TECHNICAL BULLETIN
Bell Helicopter **TEXTRON**
A Subsidiary of Textron Inc.

NO 407-00-21

MODELS AFFECTED: 407

SUBJECT: **TAIL ROTOR GEARBOX CASE ASSEMBLY,
P/N 406-040-406-101, MODIFICATION OF.**

Figure 1. Drill Guide Tool 407-240-014-103

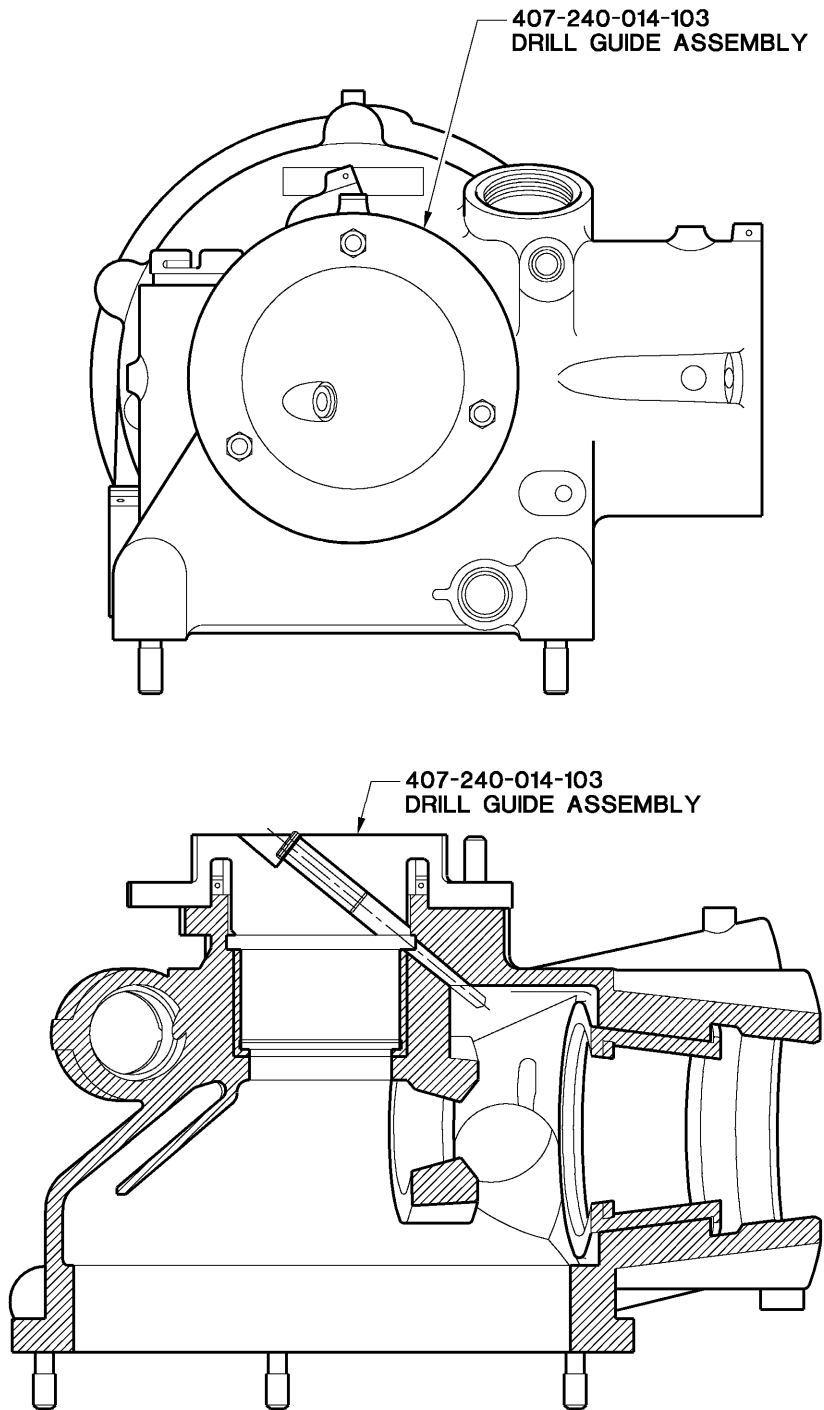
Tool P/N 407-240-014-103 is a drill guide assembly to drill a 0.156 inch (3.962 mm) diameter hole through the gearbox case at the bearing gallery and tool P/N 407-240-014-105 is a drill guide assembly to drill a 0.187 inch (4.749 mm) diameter hole to drain oil from the vent bore. These tools are available through your Bell Helicopter Supply Center.

1. Drain hole for bearing gallery :
 - a. Remove the tail rotor gearbox (Refer to Maintenance Manual BHT-407-MM-7, Chapter 65).
 - b. Disassemble the tail rotor gearbox assembly (Refer to BHT-407-CR&O, Chapter 65, for instruction).
 - c. Clean the gearbox case. Make sure that paint or sealant is fully removed from the gearbox surface that connects with the drill guide.
 - d. Install the drill guide tool 407-240-014-103 on the gearbox case assembly and attach with the existing hardware (Figure 1).
 - e. Use a short fluted twist drill bit 5/32 inch or equivalent drill 0.156 inch (3.962 mm) diameter. Lubricate the drill with cutting oil to drill the hole through the case.
 - f. Remove the drill guide tool 407-240-014-103.
 - g. Use a Swiss file or equivalent to de-burr the sharp edges of the holes.

Figure 2. Drill Guide Tool 407-240-014-105

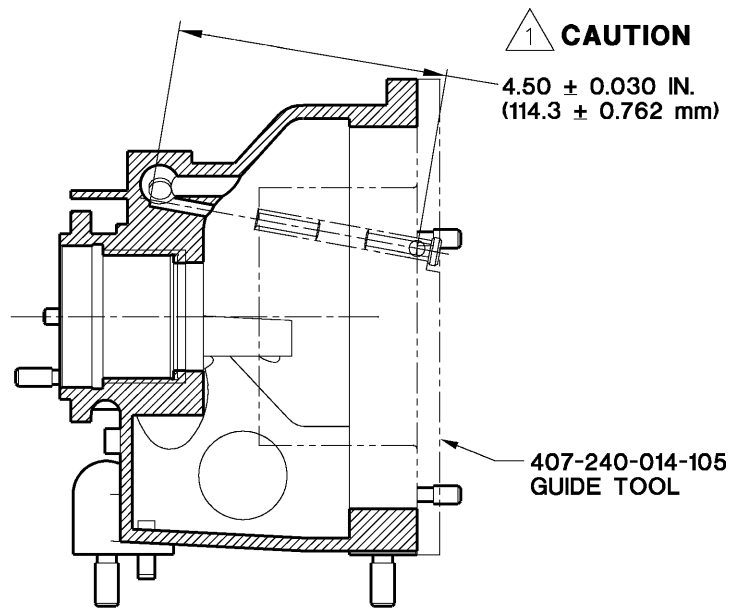
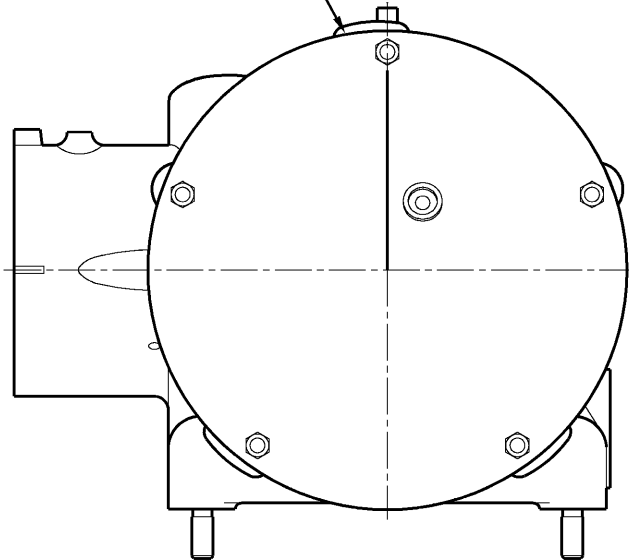
2. Drain hole for vent hole bore:
 - a. Make sure that the paint or sealant is fully removed from the gearbox surface that connects with the drill guide.
 - b. Install the drill guide tool 407-240-014-105 on the gearbox case assembly and attach with the existing hardware (Figure 2).

THE DISTANCE BETWEEN DRILL PLATE GUIDE ASSEMBLY 407-240-014-105 AND THE BOTTOM OF THE VENT CAVITY IS 4.50 ± 0.030 INCH (114.300 ± 0.762 MM). ENSURE HOLE DOES NOT EXCEED THIS DEPTH.

- c. Install a drill stop or equivalent at 4.50 ± 0.030 inch (114.300 ± 0.762 mm) from the point of a short fluted twist drill bit $3/16$ inch or equivalent drill 0.187 inch (4.749 mm) diameter. Lubricate drill with cutting oil and drill a hole to the bottom of the vent cavity. (Figure 2).

The distance between drill plate guide assembly 407-240-014-105 and bottom of vent cavity is 4.50 ± 0.030 inches (114.30 ± 0.762 mm). Ensure hole does not exceed this depth.

Figure 3. Mod Plate installation

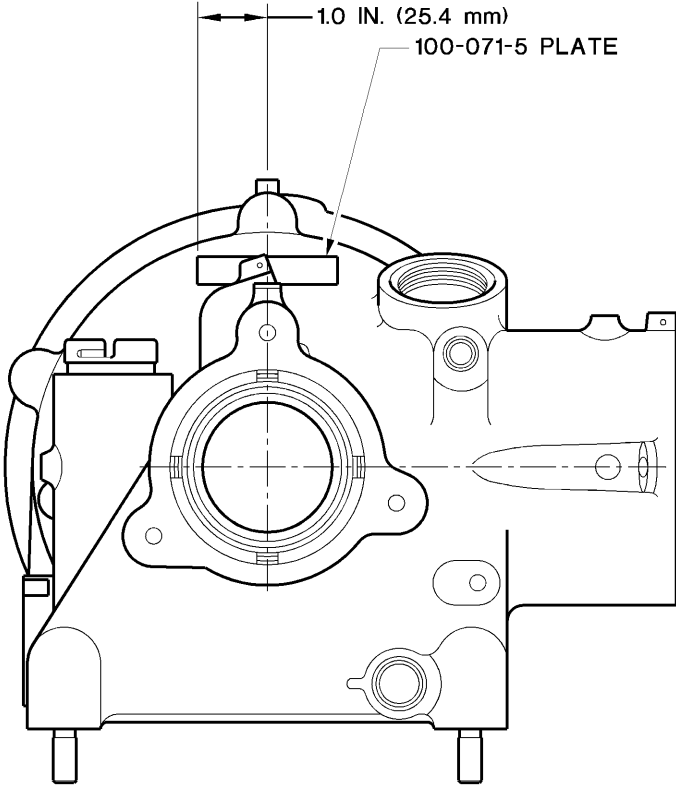
4. Apply Corrosion Preventive "DOW #19" (C-103) to reworked area. (Refer to Corrosion Control Guide Manual.)
5. Use a Vibrating stylus, mark the Mod plate 100-071-5 as follows: 407-540-001-101.

6. Apply adhesive (C-317) to the Mod plate 100-071-5.
7. Install the Mod plate on the gearbox (Figure 3).
8. Assemble the tail rotor gearbox (Refer to CR&O Manual).
